From: Granger, Michelle
To: Oconnell, Kimberly
Subject: FW: Pohatcong OU3 Response-To-Comment backcheck for Draft RDWP
Date: Thursday, January 25, 2018 9:22:54 AM
Attachments: [RTC Draft RDWP+QAPP \(Rev 9\) FINAL USACE back check.docx](#)
[RTC Draft RDWP+QAPP \(Rev 9\) FINAL USACE back check.pdf](#)

From: Hauber, Erin M CIV USARMY CENWK (US) [<mailto:Erin.M.Hauber@usace.army.mil>]
Sent: Friday, December 29, 2017 12:21 PM
To: Granger, Michelle <Granger.Michelle@epa.gov>
Cc: Watts, Joshua A CIV USARMY CENWK (US) <Joshua.A.Watts@usace.army.mil>; Brink, Bradley J CIV USARMY CENWK (US) <Bradley.J.Brink@usace.army.mil>; L'Ecuier, Jason R CIV USARMY CENWK (US) <Jason.R.LEcuier@usace.army.mil>; Darpinian, Amy S CIV USARMY CENWK (US) <Amy.F.Darpinian@usace.army.mil>; Bonney, Conrad H CIV USARMY CENWK (US) <Conrad.H.Bonney@usace.army.mil>
Subject: Pohatcong OU3 Response-To-Comment backcheck for Draft RDWP

Pohatcong OU3 Draft RDWP Comment Matrix

Figures		
Figure 4 – Geologic Cross-Section

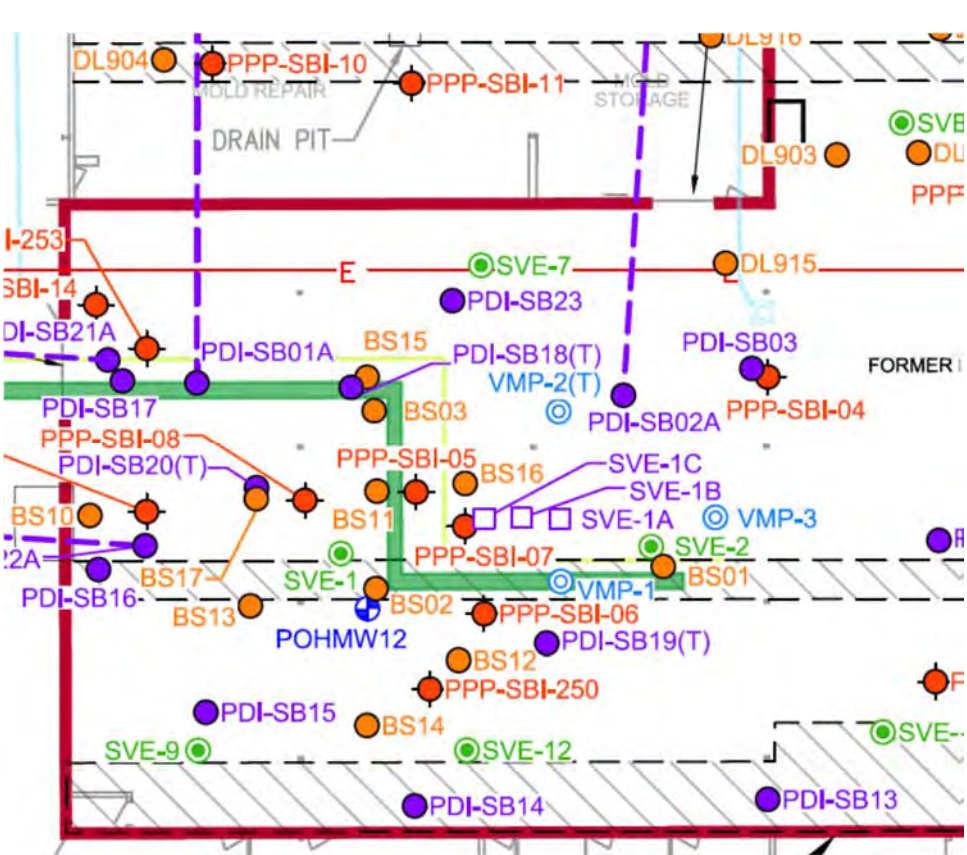
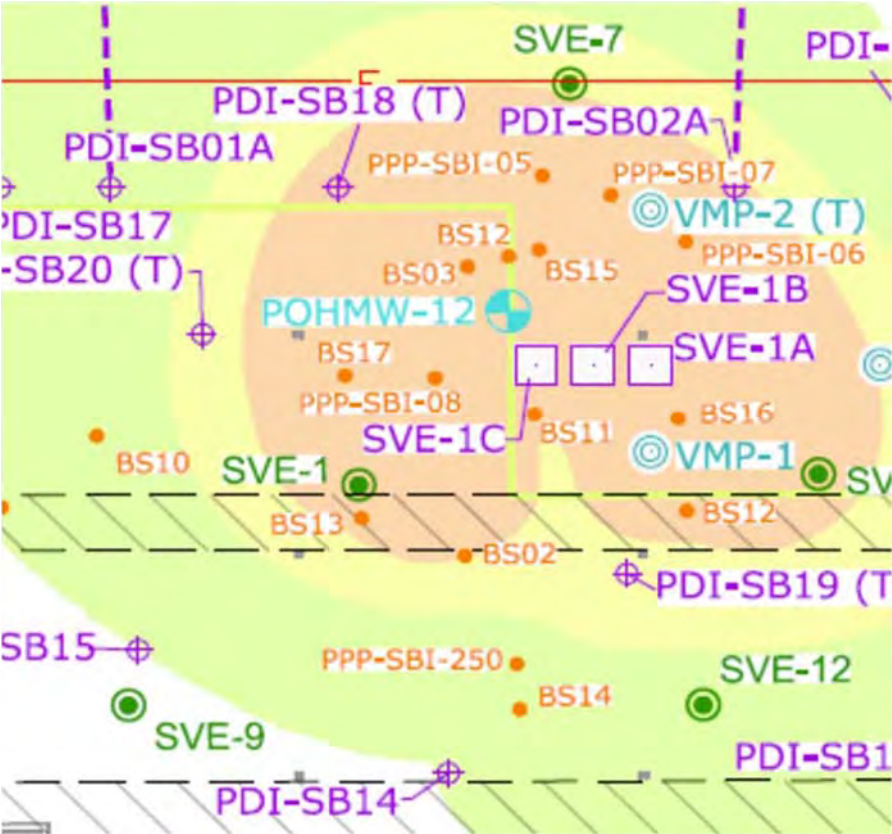
<p>1. The RI cross section included as Figure 4 in the RDWP presents very little lithologic information specific to Area A overburden. Please provide a more focused cross section specific to Area A to support the RD. Evaluate and discuss whether the downward coarsening of the silt toward the bedrock interface (mentioned in Section 2.3.2) is supported by the logs and explains contaminant distribution.</p>	<p>The Geologic Cross-Section figure was updated to provide three geologic cross-sections through Area A. The focused cross-sections are illustrated as Figures 5A and 5B in the RDWP. The drilling and boring logs from which these cross-sections were constructed were performed by multiple drill crews and logged by multiple geologists.</p> <p>Unconsolidated vadose zone grain size information is solely derived by the USCS boring log descriptions provided by the various geologists. There is an overall upward fining grain-size trend within the vadose zone. Indirect empirical evidence of an inferred fining upward grain-size trend within the vadose zone is supported by the existing TCE contaminant distribution data.</p>	<p>Concur.</p>

<p><i>Reference for Figures 5-10 Comment #1:</i></p>

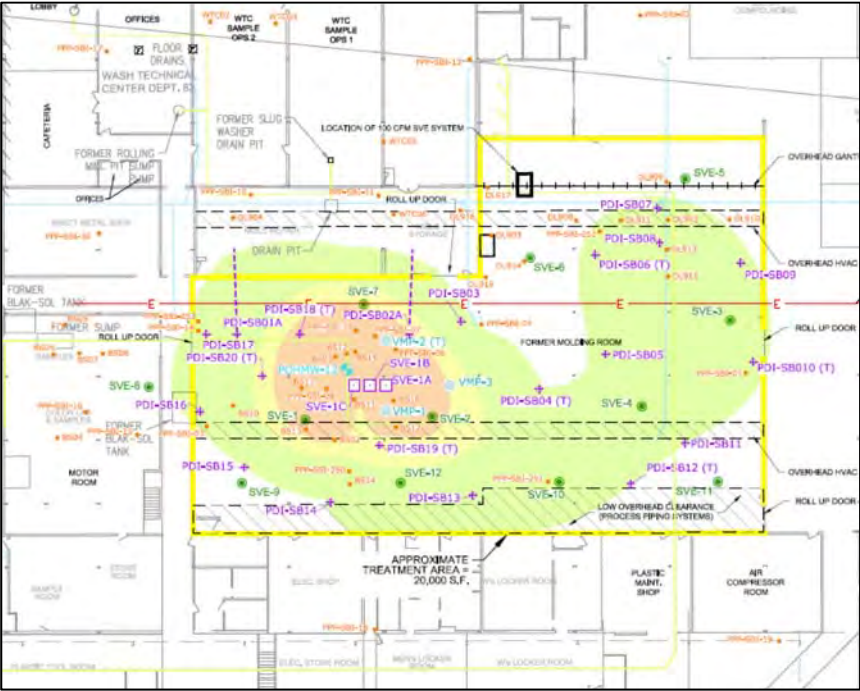
USEPA Comment	Response	USACE Back check (Dec 28, 2017)
General Comment		
<p>1. Conceptual Site Model - The lateral extent of TCE > 1 mg/kg is so much greater from 60 to 100 ft bgs compared to 0 to 60 ft. If TCE originated from leaky drain/sewer lines, migrated vertically due to density driven and/or hydraulic head and began spreading laterally from the 60-100 ft interval, is this a result of changes in vertical and/or horizontal permeability/soil architecture in this zone, greater sorption on the soil matrix in this interval, other reasons? Please include an updated discussion of the CSM within the Pilot/Treatability Study Evaluation Report. Also, please add P/TSE Report to the acronym list.</p>	<p>Per USEPA's request, an updated discussion of the CSM will be provided within the forthcoming Pilot/Treatability Study Evaluation Report. Based on information contained in the May 2016 Final Remedial Investigation Report and June 2016 Final Feasibility Study Report, a discussion of the CSM has also been included in Section 2.5 of the revised Draft RDWP. Pilot/Treatability Study Evaluation (P/TSE) has also been added to the acronym list of the RDWP and the SVE Pilot Test Work Plan.</p>	<p>Concur.</p> <p>Note to EPA: Additional text added to Section 2.5 indicates Ramboll-Environ's hypothesis that soil architecture / change in permeability is responsible for higher lateral distribution from 60-100 ft. Response to Figure Comment #1 indicates upward fining/downward coarsening may explain greater extent mass at depth. The P/TSE will include an updated CSM based on additional borings. Also, model assumptions appear to have adjusted estimated extent of TCE (EVS volume of soil >1 mg/kg TCE went from 6,800 cubic yards to 13,110 cubic yards). See image at end of table comparing RDWP figures.</p>

<p><i>Figures 5–10 – Extent of TCE in Soils at varying depths</i></p>		
<p>1. Figures 5 – 10 - There appears to be discrepancies between the 2006 BS boring locations presented on Figures 5 through 10 of the RDWP and the 2007 PPPI RI Report, Plate 5.</p> <p>For example, was BS11, the location with the single highest soil concentration, west of MW12 (Plate 5) or east of MW-12 (RDWP)? Where is the sanitary sewer drain line in relation to these borings? Why are there two BS12's shown in RDWP?</p> <p>A screen shot of the two figures has been included at the end of the comments.</p>	<p>The observed discrepancies in the past soil boring locations have been reviewed, and corrected boring locations are presented in the figures of the revised Draft RDWP.</p>	<p>Concur.</p> <p>Were these changes responsible for the adjusted contaminant distribution depicted in Figures or were other modeling assumptions (e.g., kriging confidence intervals) also adjusted?</p>

Draft RDWP (6,800 cy >1 mg/kg TCE)

Draft Final RDWP (13,110 cy >1 mg/kg TCE)
